Meeting Date: June 7, 2015

Hearing Body: Planning and Zoning Commission

Location: 60 Sinagua Drive

Project Summary: New 3,808 square foot Commercial Warehouse

WAREHOUSE FLOOR PLAN

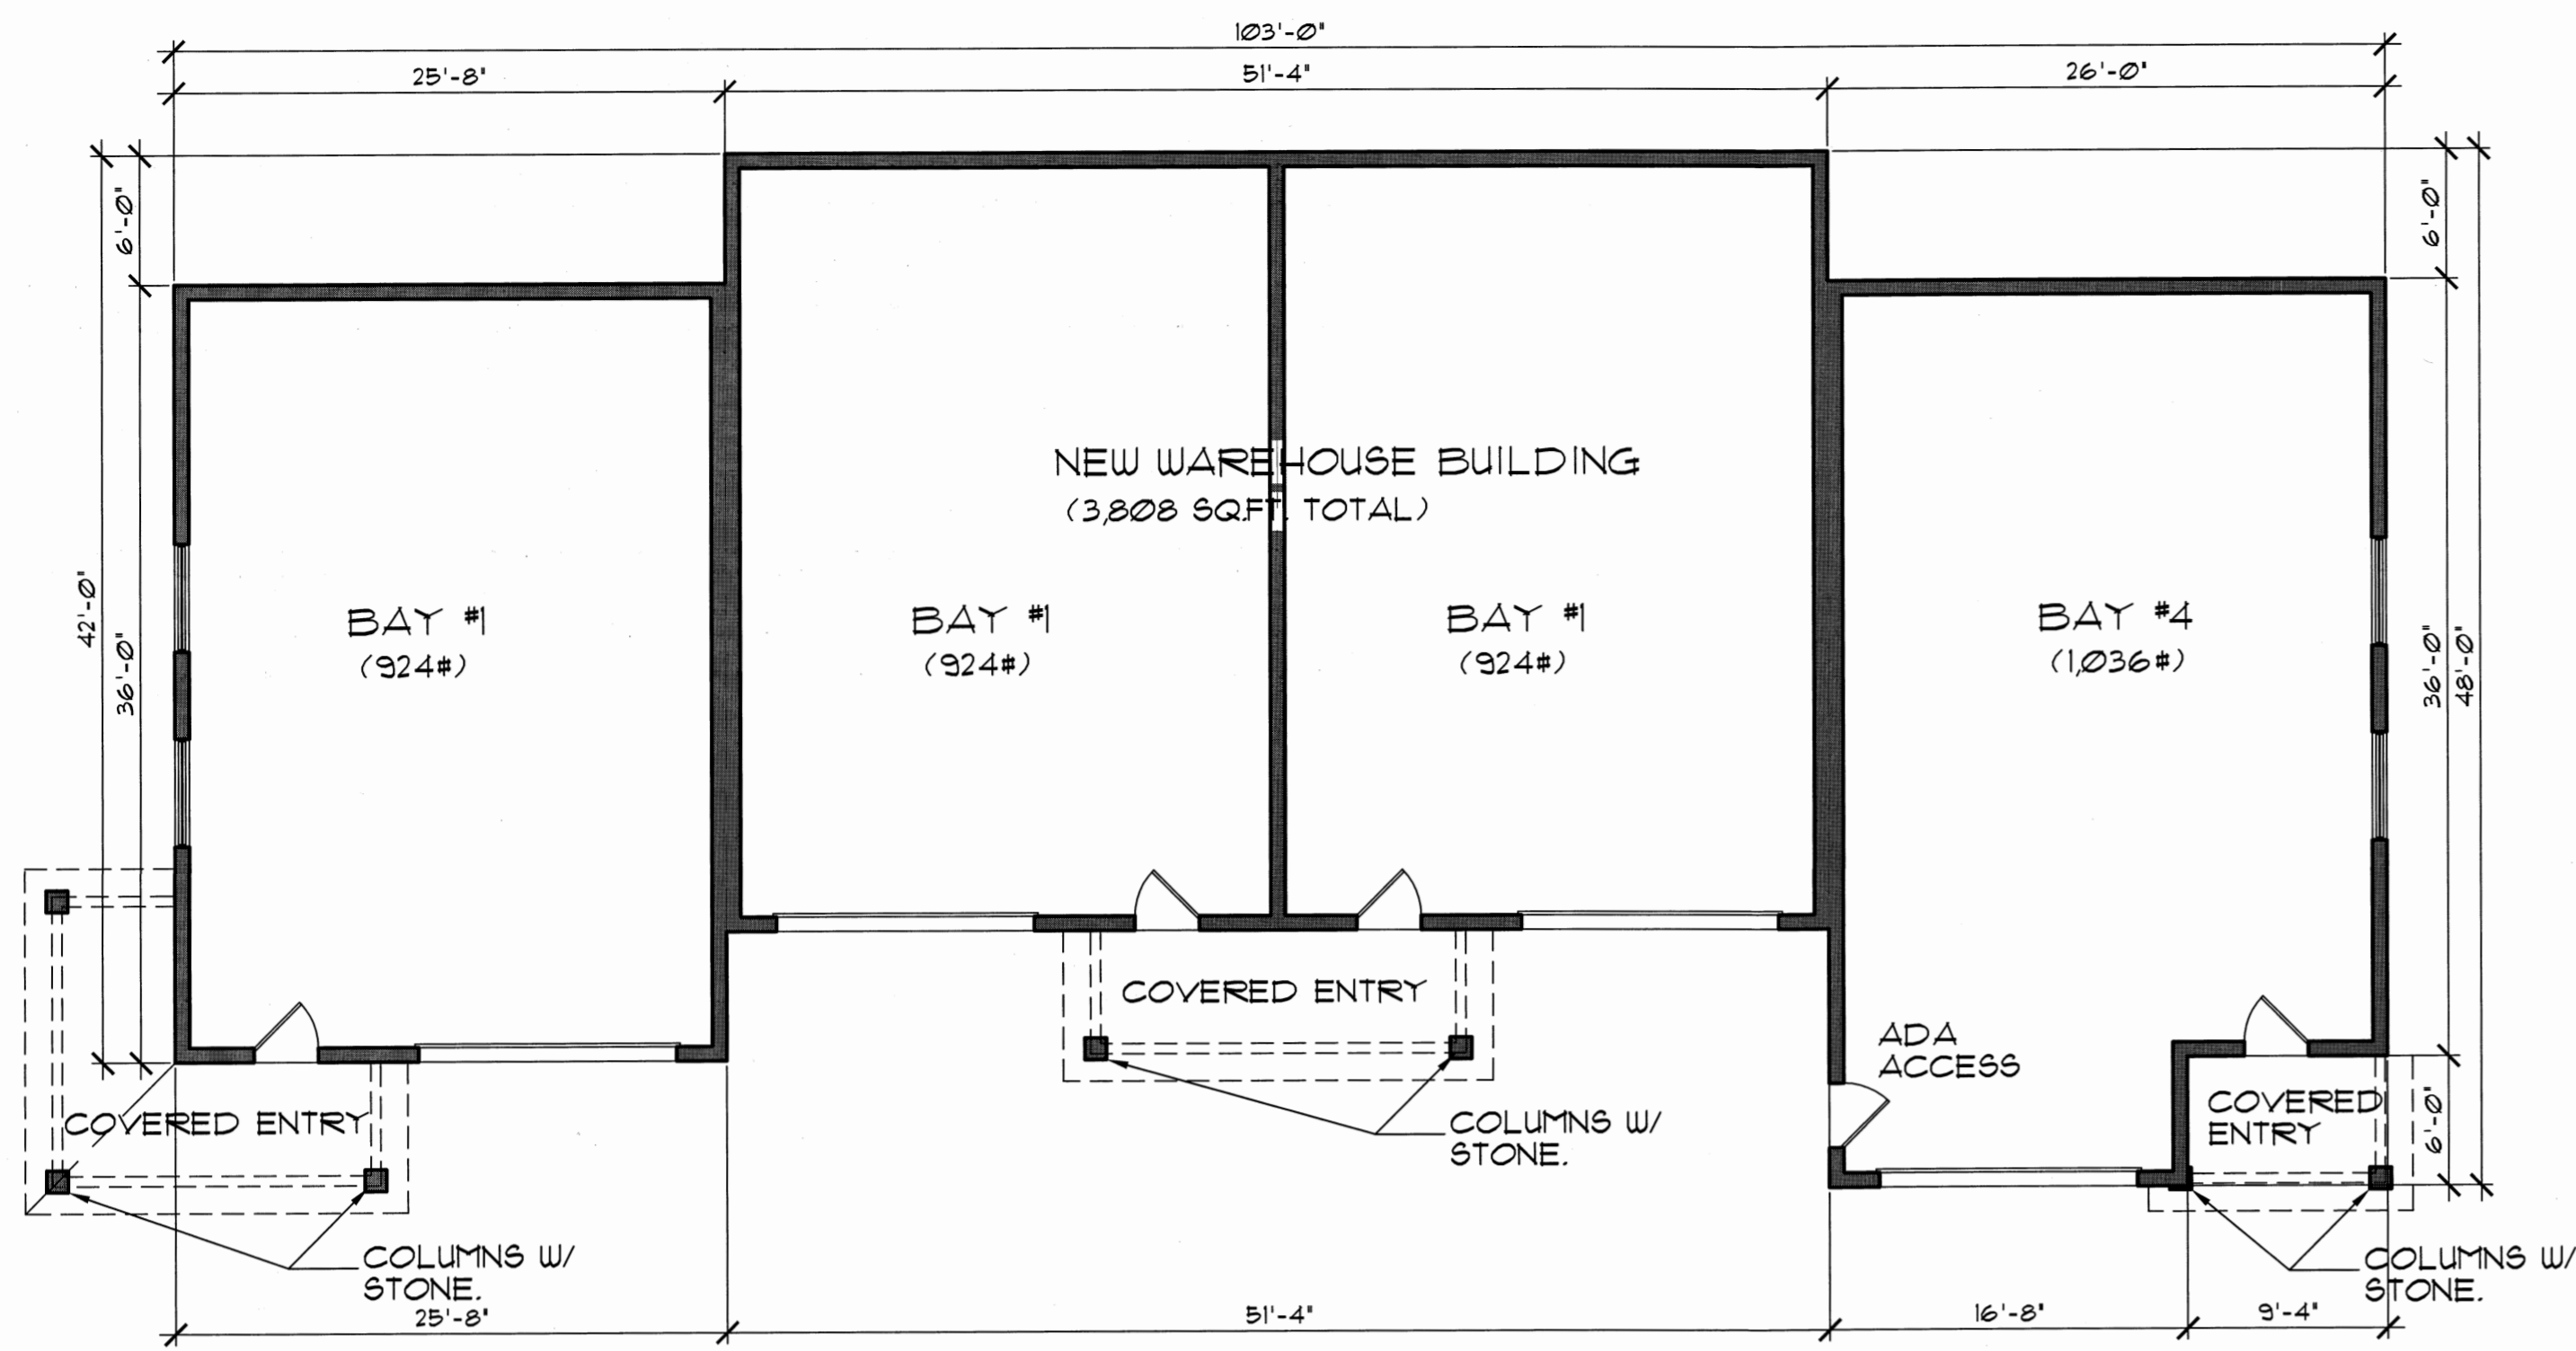
903.03.B Required Massing	<p><i>Evaluation:</i> The building has 3 masses in plan view and in elevation view. The site plan shows the offset in the northeast corner at 5’8” while the other plans show it as a 6’0” offset. This is required to be 6’0” in order to meet massing requirements. Staff has discussed this discrepancy with the architect who has confirmed the correct measurement is 6’0”. This will be included as a condition of approval and will be reviewed for compliance by Staff during building permit review.</p> <p><i>Compliance:</i> <input checked="" type="checkbox"/> Yes <input type="checkbox"/> Partial <input type="checkbox"/> No <input type="checkbox"/> Not Applicable</p>

9. The plans submitted for building permit review shall reflect the following conditions:
 - a. The offset of the easternmost mass from the center mass is required to be 6'0" to meet massing requirements.

LANDSCAPE/SITE PLAN
SCALE: 1/8" = 1'-0"

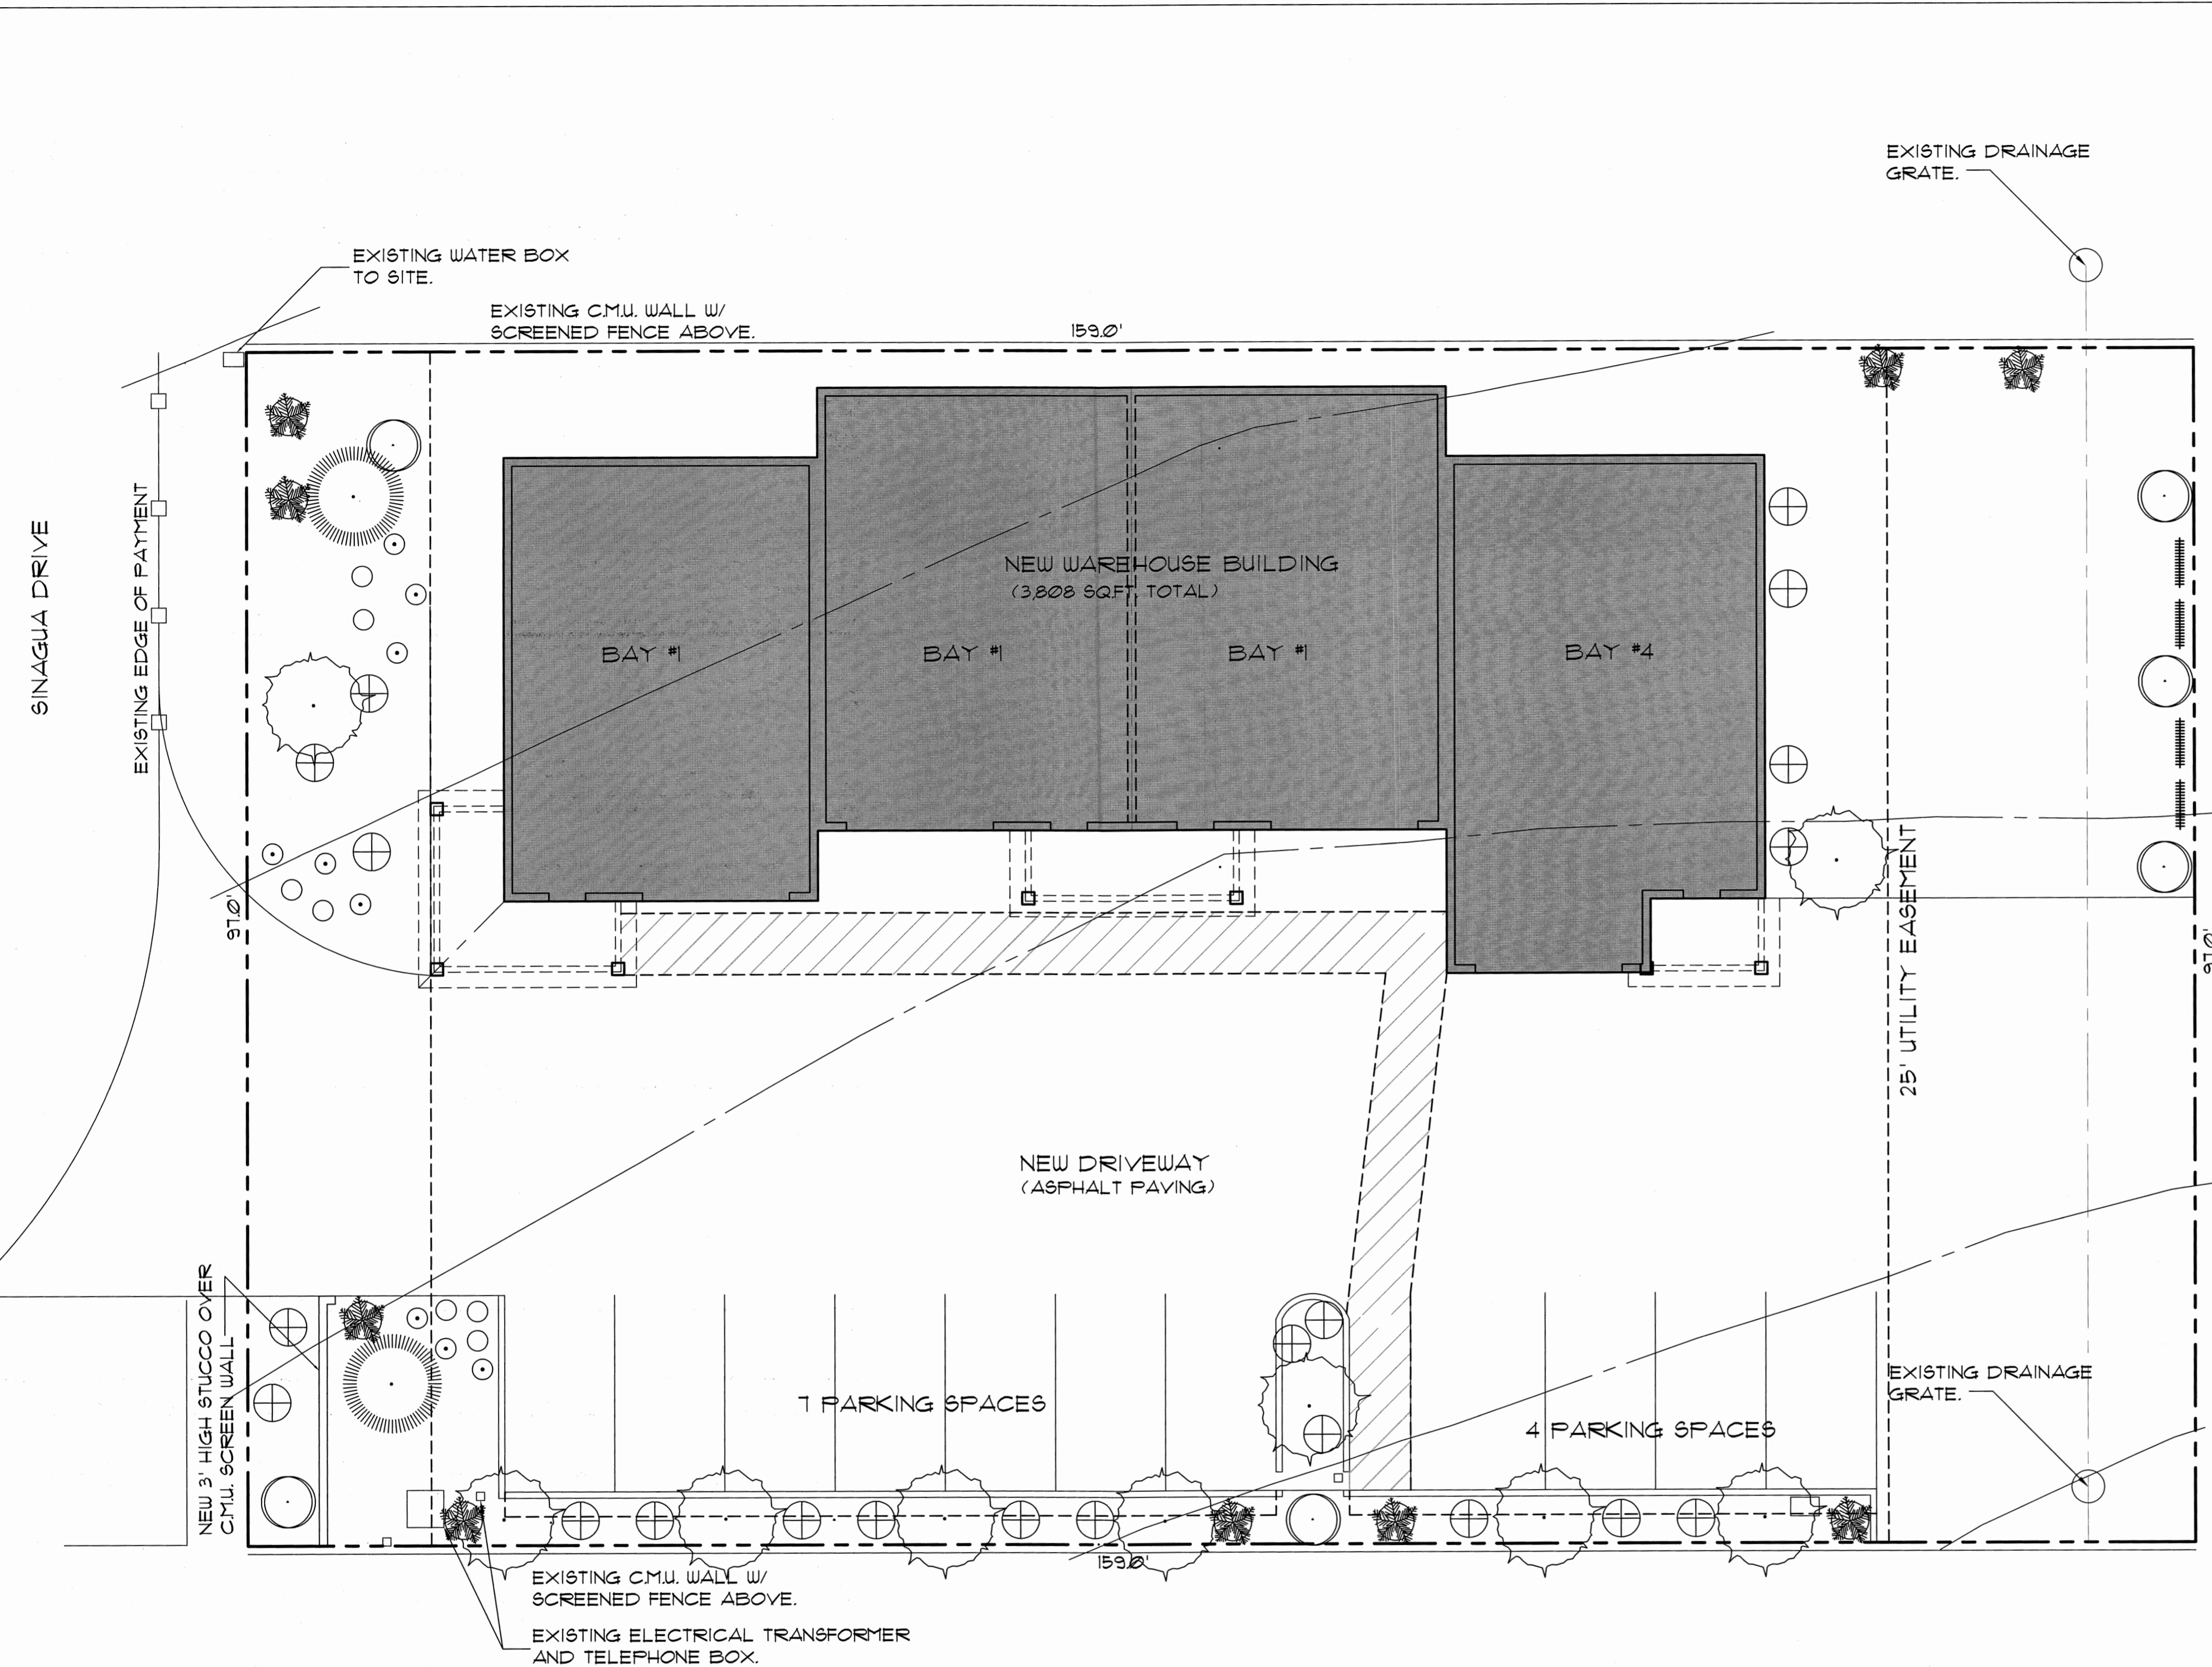
6. Landscaping Plan:
 - a) On the Plant List, clearly distinguish between trees, shrubs, and groundcover, and include the total number of plants of each species proposed. Please ensure the trees and shrubs meet the plant selection requirements of SLDC 910.05.D regarding percentages of native and evergreen plants. Refer to the Plant List in the Design Review Manual for information on which plants are considered native (available online: <http://www.sedonaaz.gov/home/showdocument?id=25027>).

- b) One (1) tree and three (3) shrubs are required for every 200 square feet of landscape area between the building/parking lot and the property line. Please indicate the size of these areas and ensure the correct number of trees and shrubs are included.

- c) A 3 foot tall wall or berm between the parking area and the street is required per Code. Please modify the plan to meet this requirement.
 - d) The landscape strip between the parking area and the property line is required to be 4 feet in width. As shown, it appears to be approximately 3 feet in width. In addition, this landscape strip requires a minimum of 2 15-gallon trees and 5 shrubs for every 4 parking spaces. Please ensure the proper plant counts are shown.

- e) Landscape peninsulas are required to be 5 feet wide with 1 canopy tree and 3 shrubs. The peninsula shown is approximately 4 feet wide and has 4 shrubs. Please modify the plan to meet this requirement
